BLUE RIVER PLANNING AND ZONING COMMISSION MEETING FEBRUARY 2024

TO: Michelle Eddy, CMC/CPM - Town Manager/Clerk
FROM: Kyle Parag, Plan Reviewer - CAA
DATE: January 31st 2025
RE: Planning/Zoning/Architectural Guidelines review – 0266 Davis Ct

TO: Michelle Eddy, CMC/CPM - Town Manager/Clerk
FROM: Kyle Parag, Plan Reviewer - CAA
DATE: January 31st 2025
RE: Planning/Zoning/Architectural Guidelines review – 0189 Gold Nugget Dr

DRAWING TITLE:
SITE PLAN

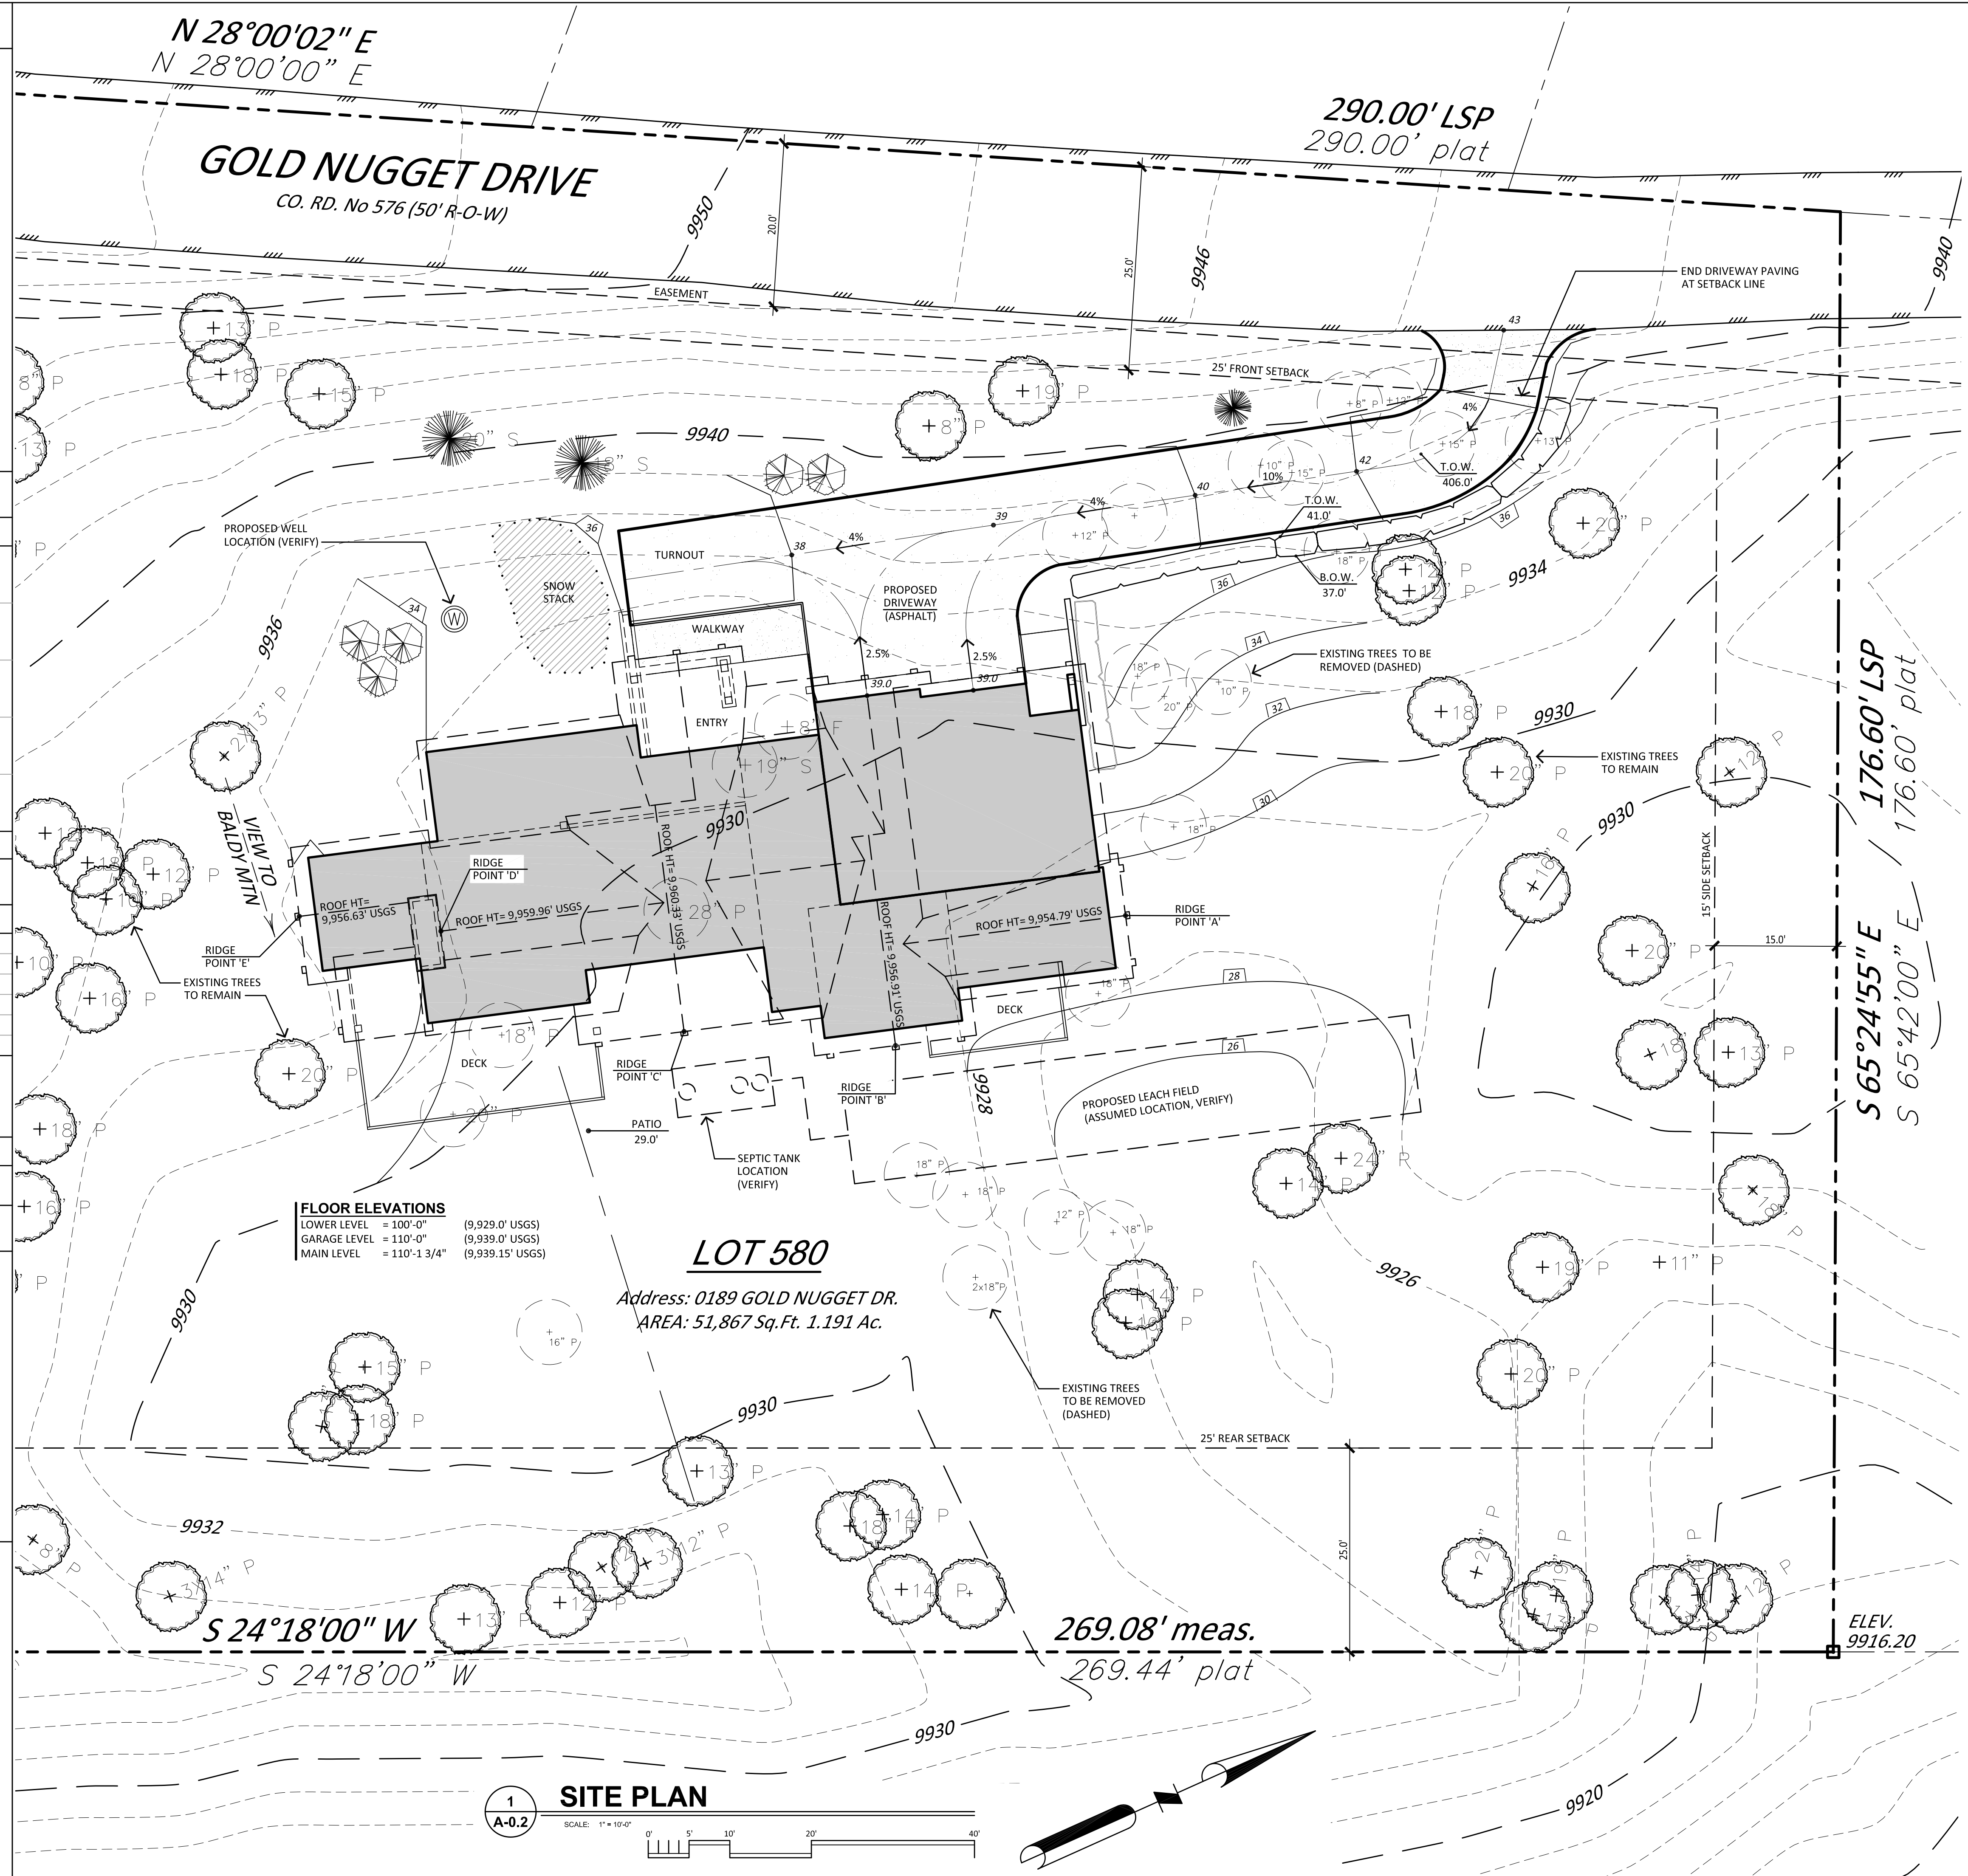
Height: Complies with required height limitations. The height at the highest roof ridge is proposed at 30'-8" --35' permitted. Indicated on sheet A0.2 as 31.33'
